WASHINGTON STATE UNIVERSITY  
REACTOR  
LICENSE NO. R-76  
DOCKET NO. 50-27

Response to Request for Additional Information  
Regarding HEU/LEU Conversion

**RESPONSE TO REQUEST FOR ADDITIONAL  
INFORMATION WASHINGTON STATE UNIVERSITY  
MODIFIED TRIGA REACTOR DOCKET NO. 50-27**

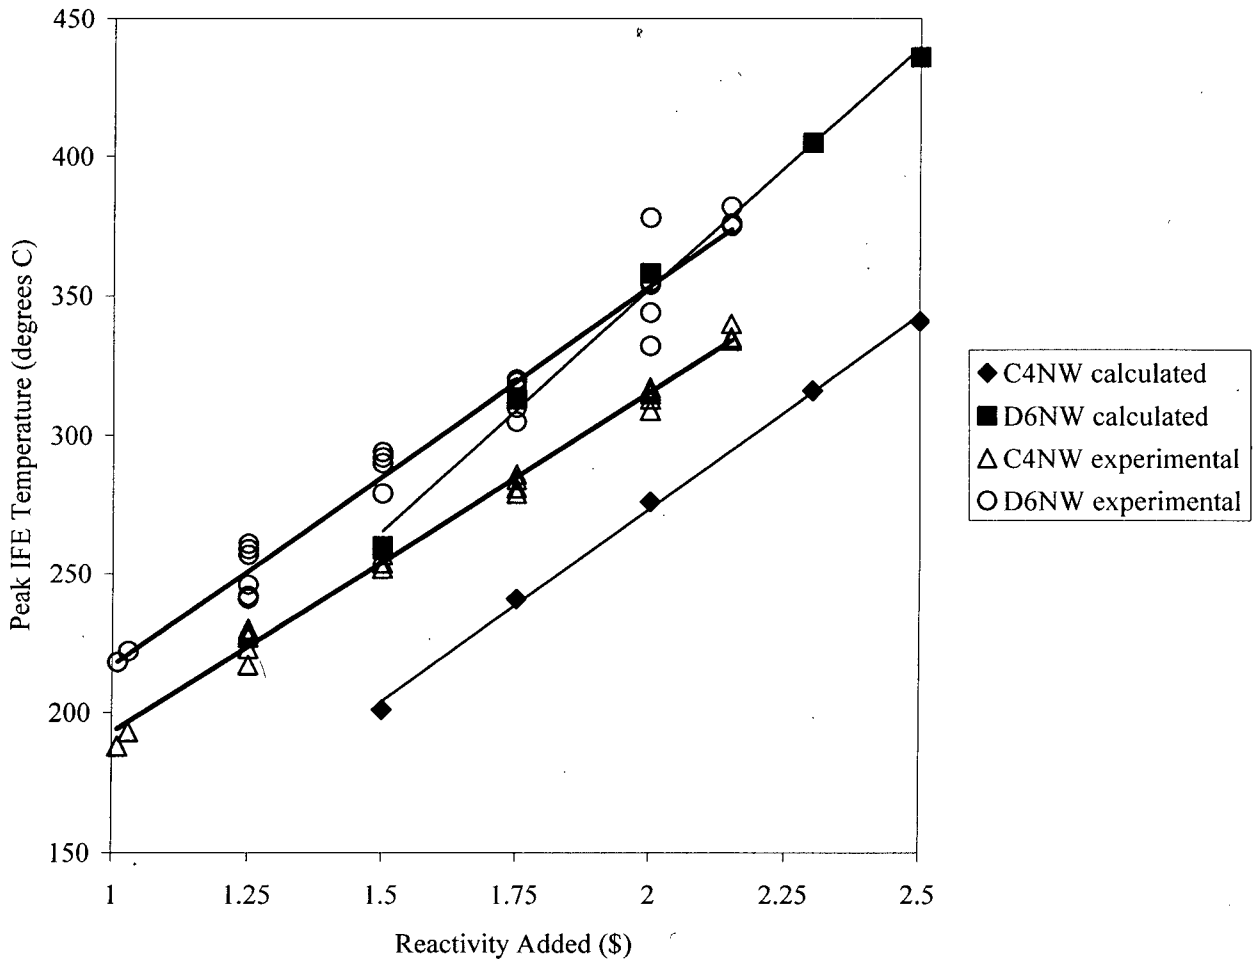
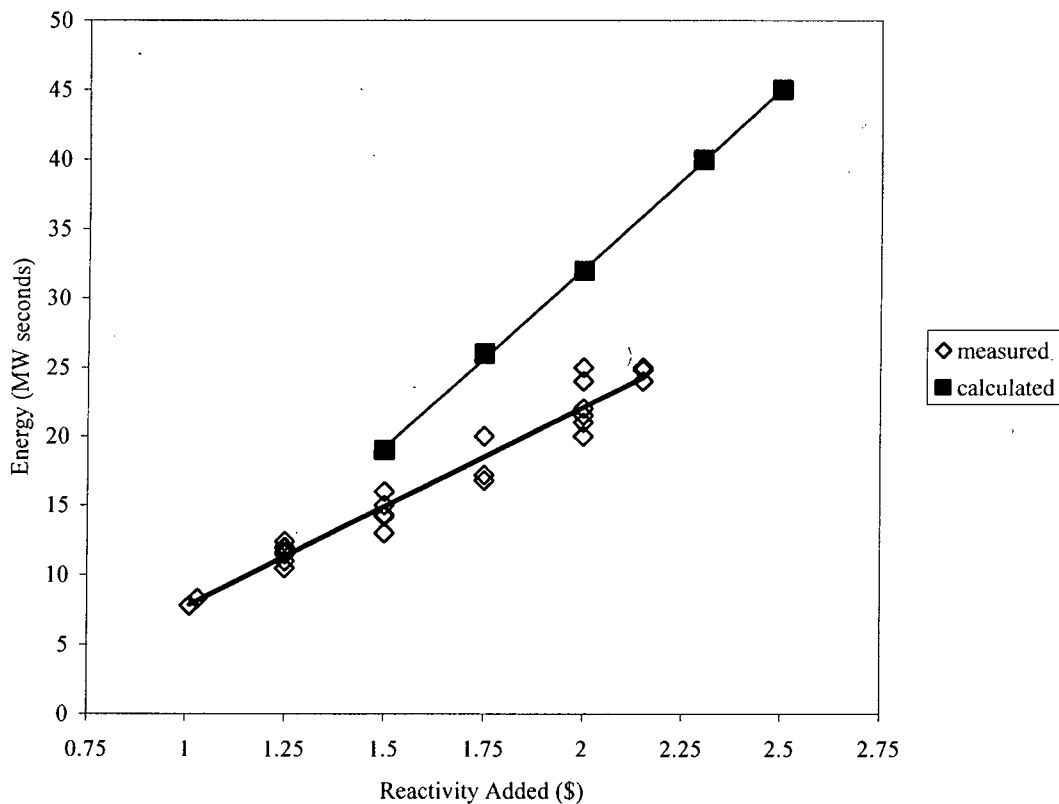
**6. Table 2 and Section 4.5.10. Table 2 has a calculated maximum pulsed reactivity insertion of \$2.02 for mixed core 34A while the historical pulsing data has reactivity additions of \$2.15. Please explain**

The data presented in Table 19 from the SAR is for mixed core 34A, and is based upon calculations performed with the BLOOST code. Table 20 from the SAR provides a larger pool of historical pulsing data. Both tables are reproduced below. The peak temperatures for rod position D4NE were also calculated and have been added to the reproduction of Table 20. A complete discussion of the calculation methodology is presented in the response for RAI Question 22. Comparison of the experimentally determined pulsing data and the modeled data demonstrate the model underestimates peak power, total energy release and peak temperatures.

A systematic analysis of historical pulsing data was undertaken by plotting the peak temperature of the IFE's I D6NW and C4NW as a function of reactivity insertion. The plot is illustrated below.

A systematic analysis of historical pulsing data was undertaken by plotting the peak temperature of the IFE's I D6NW and C4NW as a function of reactivity insertion. The calculated and experimentally measured peak temperatures are plotted below.

The equations for the BLOOST calculated best fit lines for the IFE's in core positions D6NW and C4NW are  $174^{\circ} \text{ C}/\$ + 4.4^{\circ} \text{ C}$  and  $139^{\circ} \text{ C}/\$ - 4.9^{\circ} \text{ C}$ , respectively. The equation for the best fit lines for measured peak temperatures for D4NE and C4NW are  $136^{\circ} \text{ C}/\$ + 80^{\circ} \text{ C}$  and  $123^{\circ} \text{ C}/\$ + 70^{\circ} \text{ C}$ , respectively.

Both plots do not give y-intercept values that are close the initial fuel temperature of approximately  $30^{\circ} \text{ C}$ . It is apparent that BLOOST under predicts initial fuel temperature, and over predicts the change in fuel temperature as a function of the amount of reactivity added

during pulsing, and over predicts peak fuel temperature at pulsing values greater than about \$2. The over prediction of the temperature dependence would be particularly important when using BLOOST to determine upper limits on reactivity insertions for pulsing, and may give a result which is conservative, i.e. over constrains the limitations placed on pulsing due to over prediction of peak fuel temperature values.

BLOOST also considerably underpredicts the peak fuel temperature in C4NW at all reactivity values. This clearly suggests that some fuel positions, such as C4NW are predicted to have lower total energy values, which in turn suggests that other fuel positions must be predicted to have higher energy values. The amount of energy released, as both calculated and measured parameters, are illustrated in the figure below. It is apparent that BLOOST over predicts the energy release by a substantial margin. The experimental data demonstrate that reactivity insertions of \$2.15 for Core 34A liberate slightly less energy than BLOOST calculates for a \$1.75 insertion. For the purposes of testing, Core 35A will be limited to \$2.00 reactivity insertion for pulsing, unless experimental data convincingly demonstrate that greater values may be safely allowed.

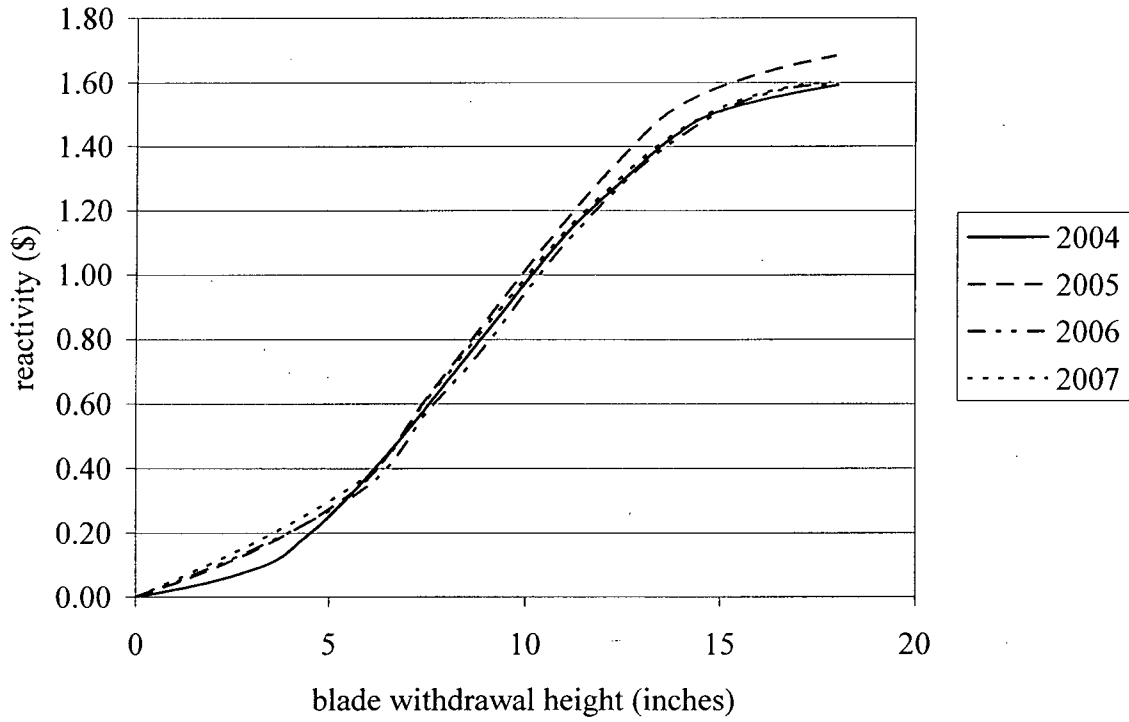
**9. Table 9. The individual calculated rod worths differ from the measured values by 28% for Blade 4 and 111 % for Blade 5. Please explain these differences? What are the estimated (uncertainties) for the measurements of the rod worths?**

The large difference between the calculated and measured values for blade 5 arises from the fact that blade 5 has a very small worth compared to the other control elements. The absolute value of the blade 5 worth is simply too small to measure accurately; if the measurement error on blade 5 is \$0.10 the relative error is about 53%.

The rod worth calculations that were performed for the SAR were carried out by modeling all five control elements in the out position, i.e. completely withdrawn from the core. Additional rod worth calculations were performed in response to this Request for Additional Information. The more recent calculations were conducted with a different control element configuration—namely by assigning each of the control blades and rod in positions wherein the reactor would be approximately critical. The core 34A became almost critical when all blades/rod were inserted 51%.

Two MCNP calculations were performed for each blade/rod to calculate the individual blade/rod worths in the new approach; one calculation with the control element fully inserted and one calculation with the control element fully withdrawn. This approach yielded calculated rod worths which closely approximate the experimentally measured values.

Fuel temperature as a function of pulse size for the WSU TRIGA reactor core 34A.

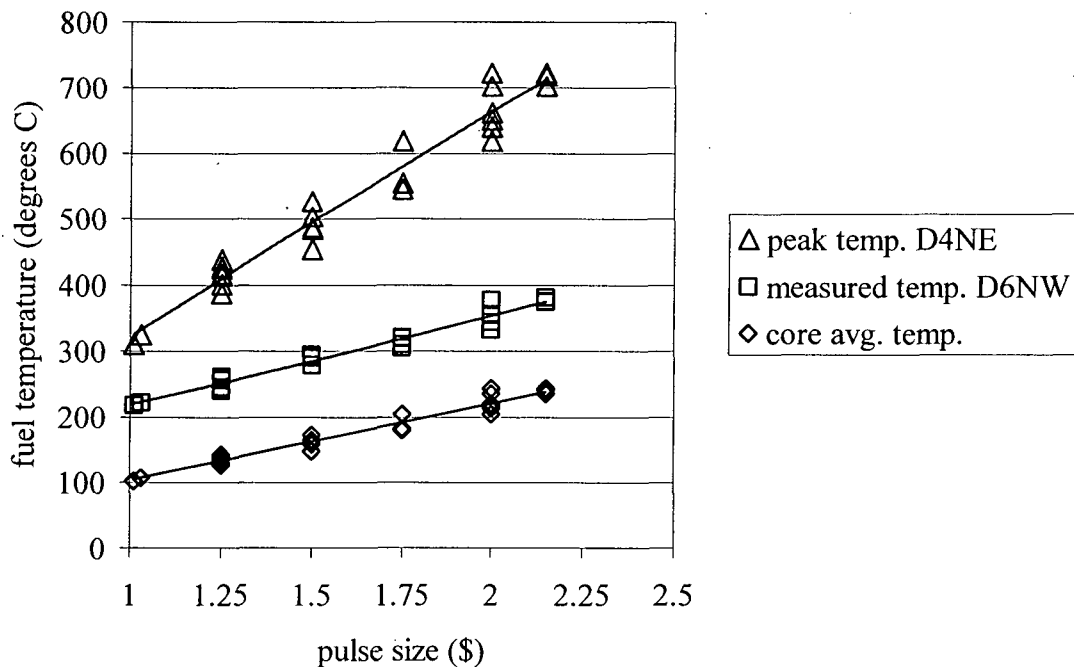
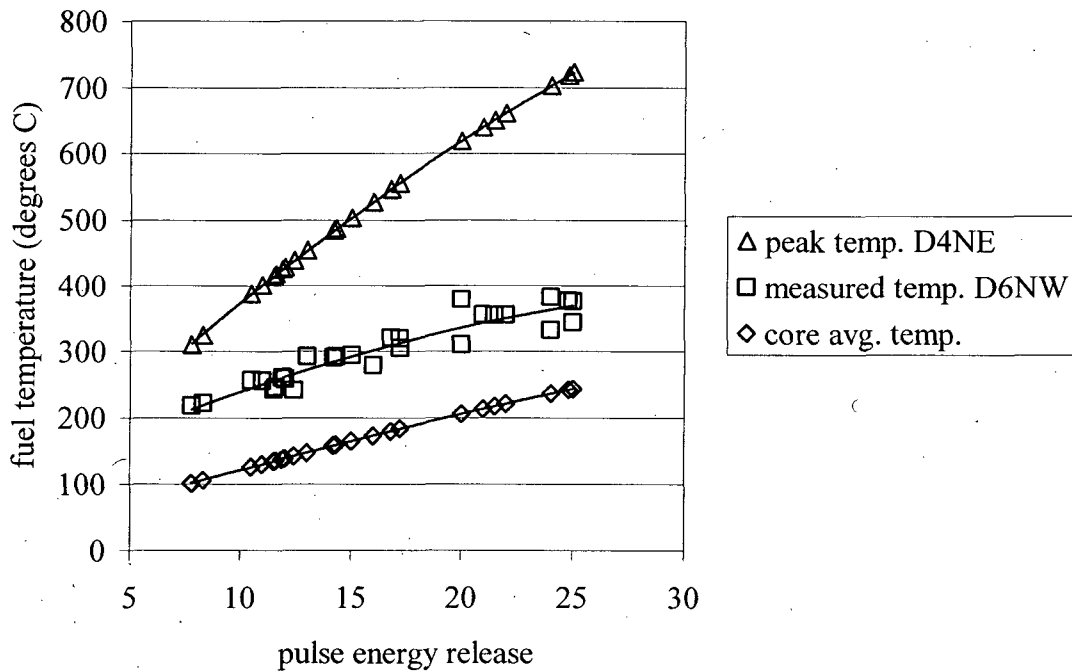
**22. Section 4.5.10. Please provide a copy of Reference 8 in order for us to understand the modeling in BLOOST. Table 19 shows that BLOOST over predicts the energy release and it under predicts the temperature increase for small reactivity insertions. Please discuss.**

The Fuchs-Nordheim variable heat capacity model has been used at WSU to determine pulsing performance for the WSU TRIGA reactor. This is a point model that yields average values for the entire core. Corrections are made for power peaking effects in the hot rod position, D4NE to determine the limiting values for pulsing. The peaking factors that were calculated by General Atomics for cold critical condition (23° C), and those used in the WSU pulsing calculations are 2.56, 1.27, 1.35 for the Rod Power Factor (RPF), Axial Power Factor (APF), and Intra-Rod Power Factor (IPF), respectively. The peaking factors decrease as temperature increases giving values of 2.47, 1.29, and 1.19 for the RPF, APF and IPF, respectively, at 280° C. Thus, the product of the peaking factors decreases from 4.39 to 3.79 at 280° C, indicating that calculations using the peaking factors for 23° C yield a calculated peak temperature value that is higher than the true value.

The temperature change of TRIGA fuel for pseudo adiabatic processes such as pulsing is related to the energy release by the Fuchs-Nordheim variable heat capacity model:

The dependence of fuel temperature on pulse size for core 34A is illustrated above. The average core temperature was calculated using the Fuchs-Nordheim relationship for measured values of energy release for each pulse. The peaking factors ( $2.56 \times 1.27 \times 1.35 = 4.39$  for RPF, APF, IPF) for  $23^\circ\text{C}$  were used to calculate the peak energy density in the hottest position in the hot rod, D4NE based on the calculated average core temperature. The peak energy density was used to calculate the peak temperatures in D4NE. The values for D6NW were taken directly from temperature indications on the reactor control console. The peak temperatures for the hottest position in D4NE for pulses of \$2.00 and \$2.15 are clearly well below the temperature limit of  $830^\circ\text{C}$  for pulsing.
